# CITY OF PORTLAND, MAINE

Project Name: The Schlotterbeck Block  
Address: 117 Preble Street  
Applicant: Schlotterbeck Block, LLC  
Planner: Shukria Wiar

Project ID: 2015-174  
CBL: 033 E001 001 and 033 E005 005

Schlotterbeck and Foss Building  
117 Preble Street  
Level III Subdivision and Site Plan Review  
2015-174  
Schlotterbeck Building, LLC, Applicant

**Figure 3 – Revised Site Plan**

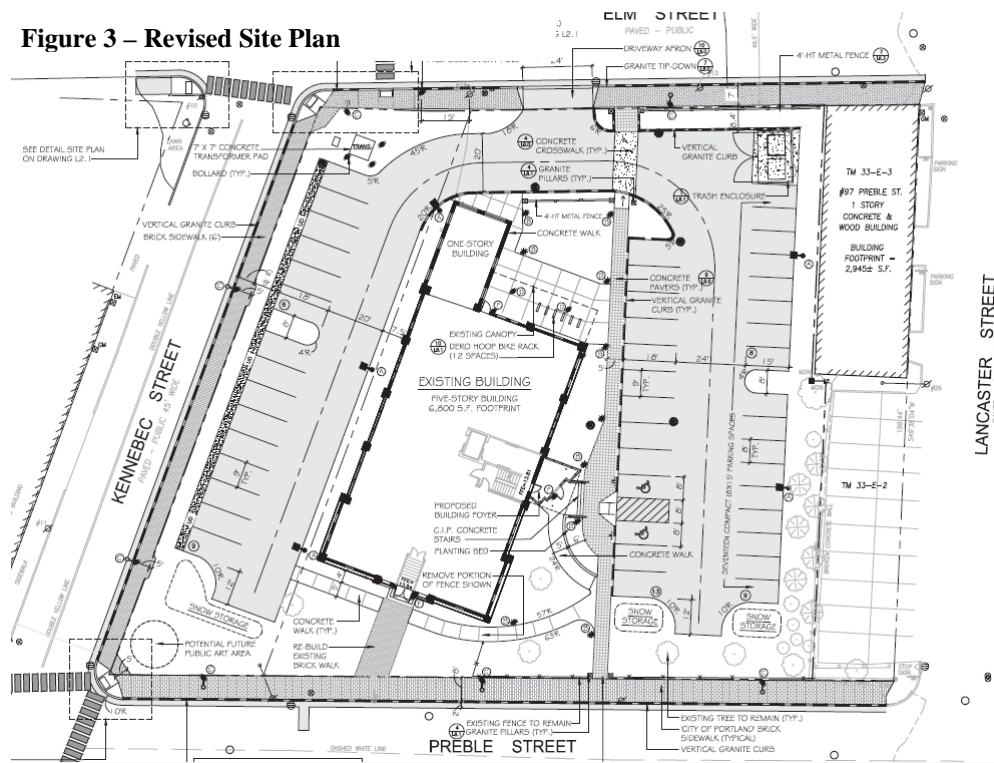
The main vehicle access is proposed from Elm Street via a new 24 foot wide drive. Surface parking lots surround the existing building and are proposed along Kennebec Street and Elm Street. Originally the applicant was proposing fifty-five (55) parking spaces. Based upon a revised parking demand analysis, the number is of parking spaces is forty-five (45). Twenty-four bicycle parking spaces proposed on the site. The parking areas are visible from the public

streets. The revised parking plan has eliminated the proposed care share for tenants. Please note the U-haul car share vehicles are available on Elm Street at the Public Library. Designated areas for snow storage are located adjacent to parking spaces.
